HIGHLAND CITY DEVELOPMENT ADMINISTRATION BOARD AGENDA

DEVELOPMENT ADMINISTRATION BOARD AGENDA REPORT ITEM #2

DATE: April 24, 2025
TO: Development Administration Board
FROM: Rob Patterson, City Attorney / Planning & Zoning Administrator
SUBJECT: **Final Plat Approval:** Vista Ridge
TYPE: **LAND USE (ADMINISTRATIVE)**

FINAL REVIEW COMMENTS

SITE DEMOLITION PLAN

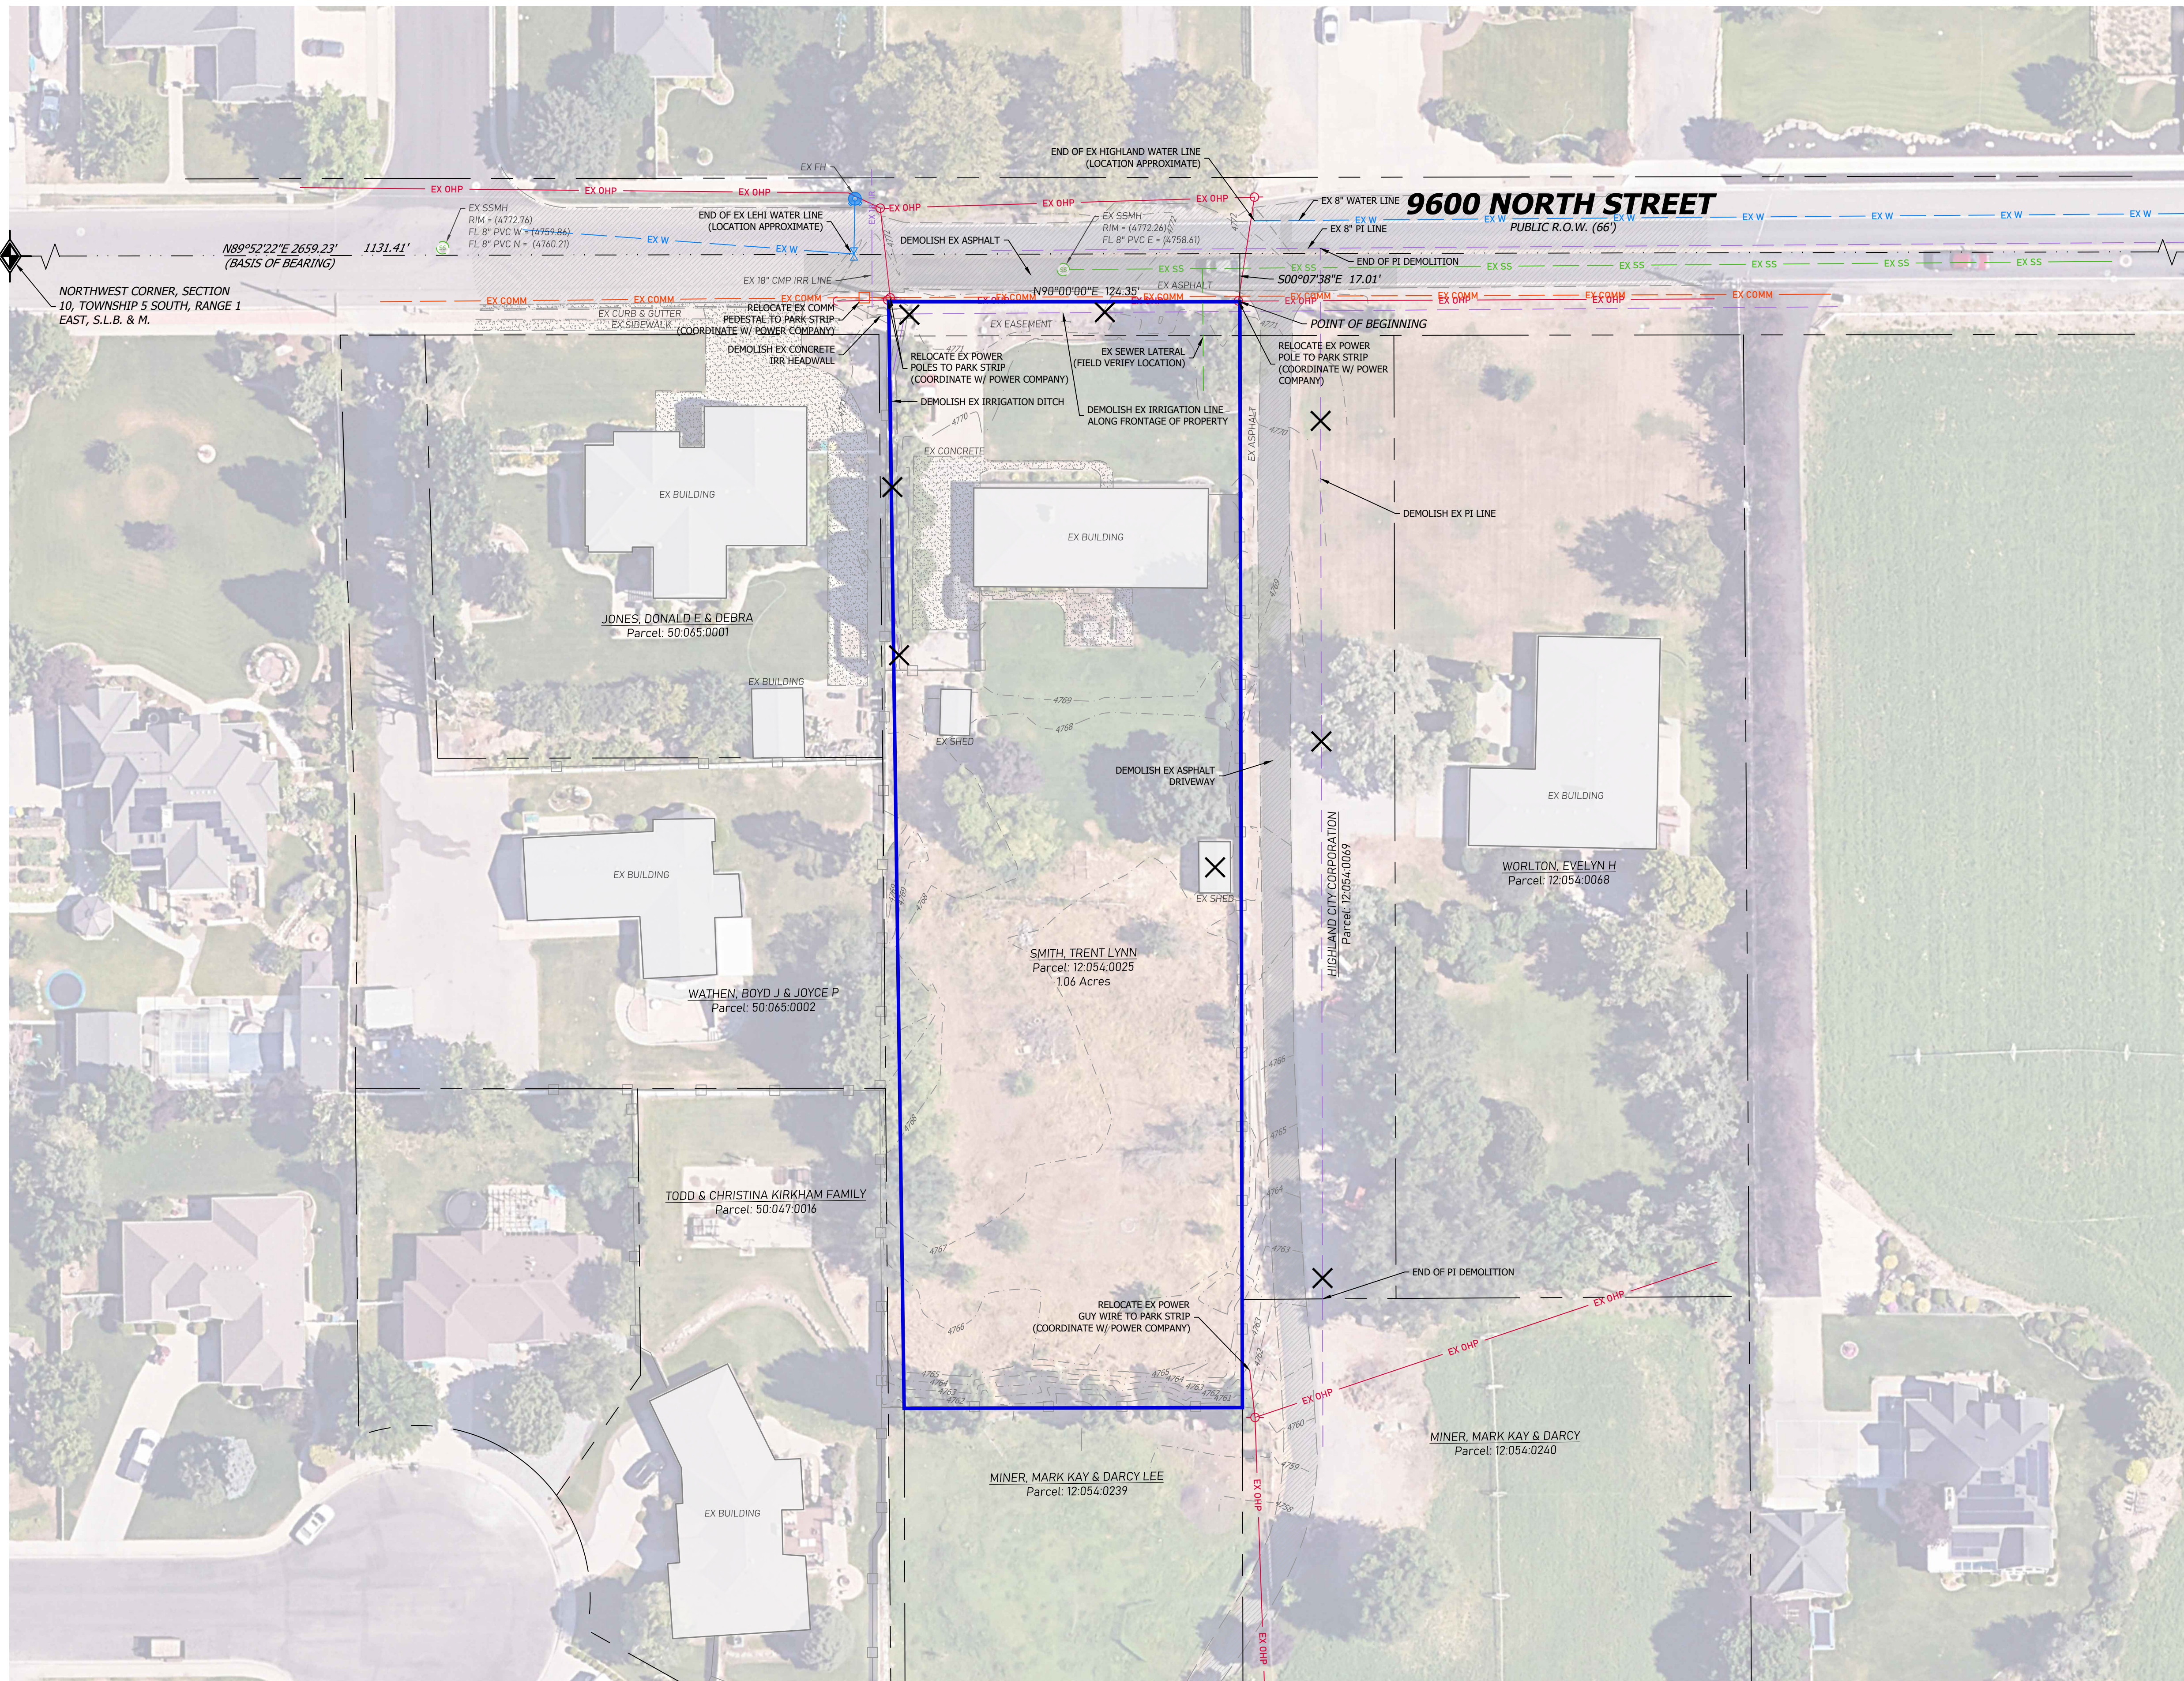
4. **Sheet C0.20 (Demolition Plan):** Correct labeling on Culinary main line in 9600N. This line is a 4" Steel line not 8". Please add the correct label.
5. **Sheet C1.00 (Proposed Site Plan):-** 8" of compacted ABC (to 95%) is the minimum allowed for a drivable surface for the Fire Department. Please indicate on the site plan that the temporary fire turnaround meets this minimum requirement.
6. **Sheet C3.9X (Detail Sheets):** Highland City standard general notes must be shown on their respective sheets in the plan sheet. PI-00 sheet is not shown correctly.
7. **Sheet C3.0 (Site Utility Plan):** At the connection point for the Culinary main in 9600N please add in the description of parts that the 8X4 reducer is to be a Flanged reducer.
8. **Sheet C4.0 (Plan & Profile):** No cover shown on PI line. Please indicate 3'-0 cover for the PI line on this sheet.
